VCSEL Reliability Calculations

802.3cz D3.0 Comment Resolution

Calculation of Hazard Rate Requires Extrapolation

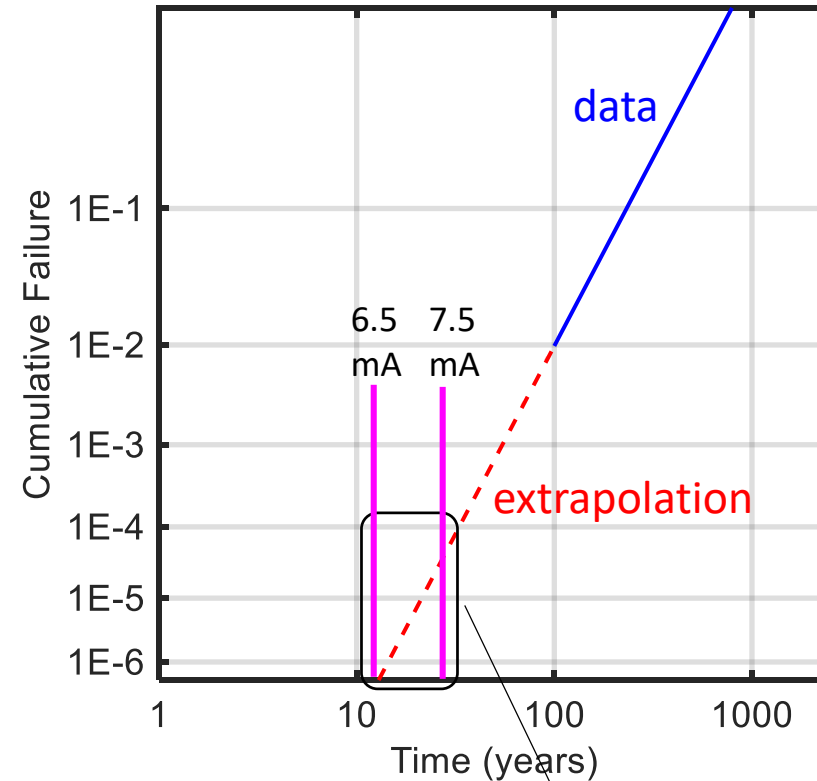
- Estimating hazard rate requires a lot of extrapolation
- Calculation of hazard rate requires taking the derivative of the cumulative distribution function $F(t)$
 - **amplifies uncertainty**
 - **cannot make bold claims**

What is the hazard rate (derivative of $F(t)$) over here?

What about extrapolation shown in our presentations?

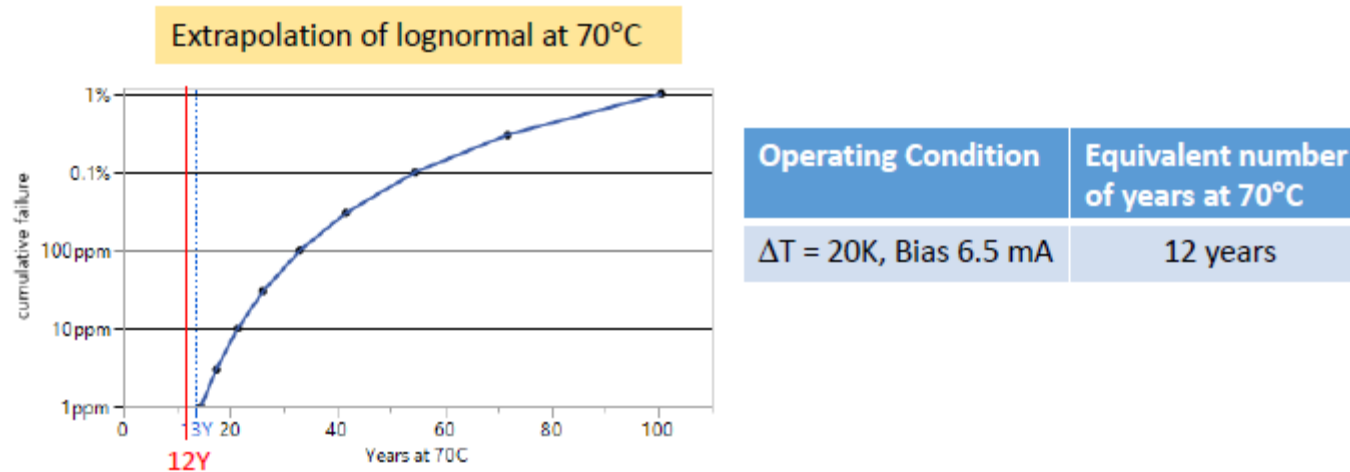
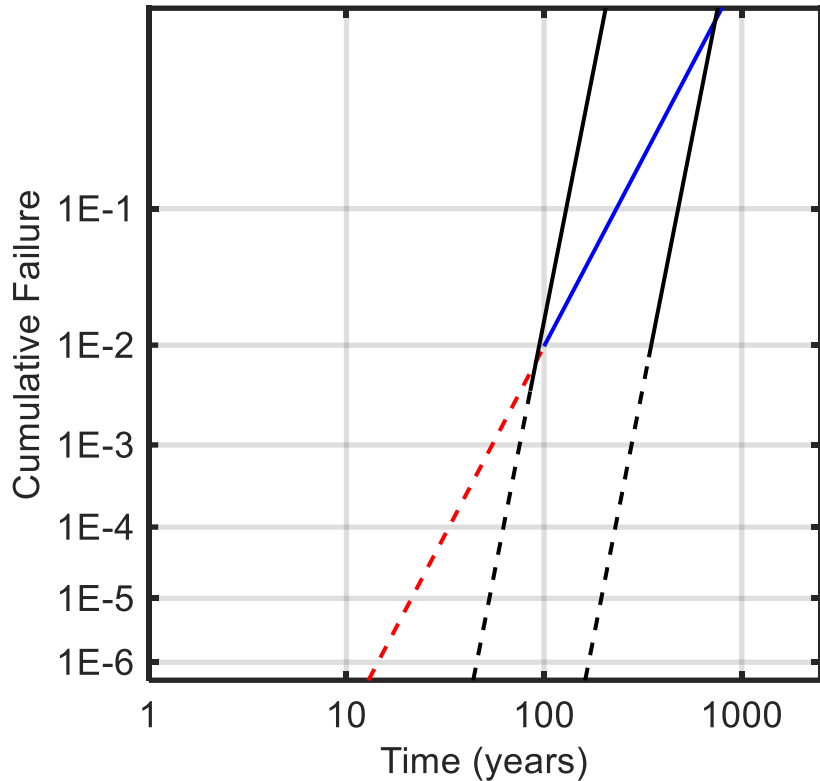
This extrapolation of the composite line was done to show how far TT 1%F was from the automotive service life.

The use of this extrapolation for calculation of hazard rate was not intended !

Failure Rate and Automotive Service Life

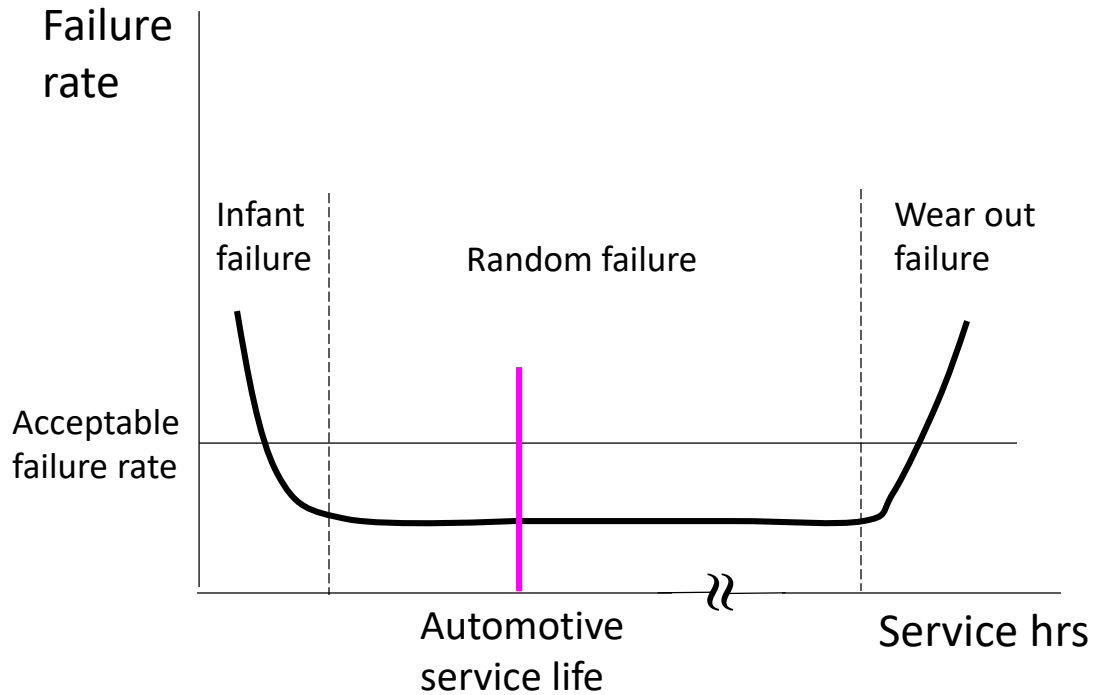
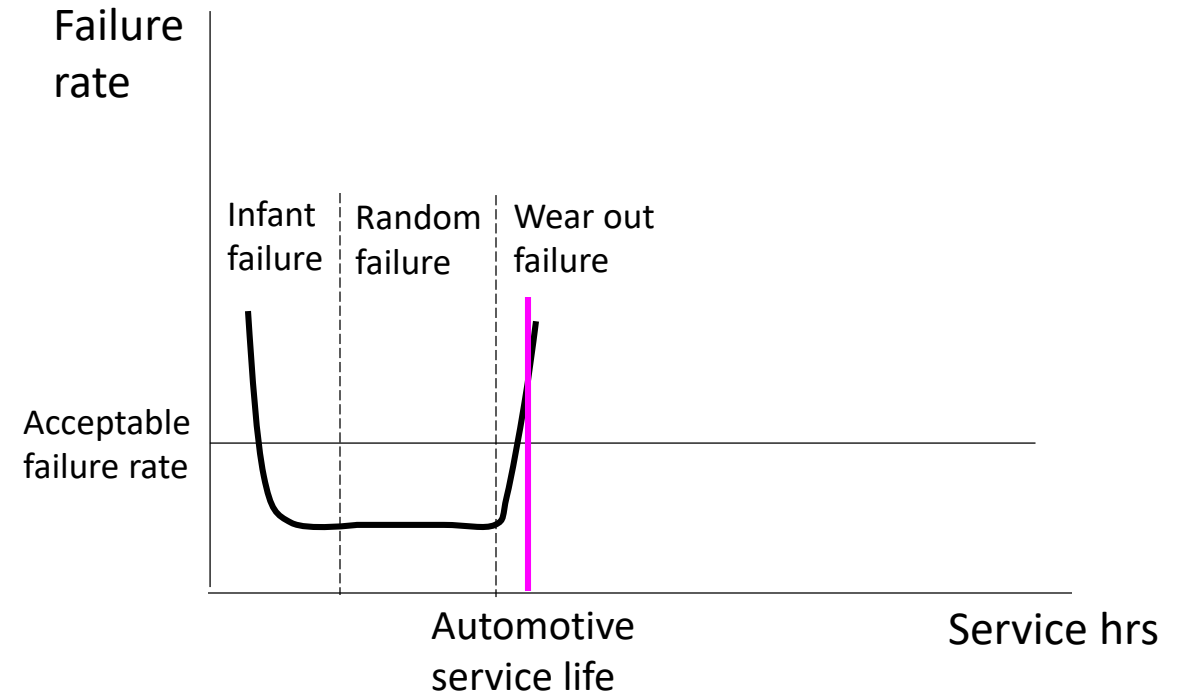
Claim in Ref [1]
This is incorrect.

Correct Picture
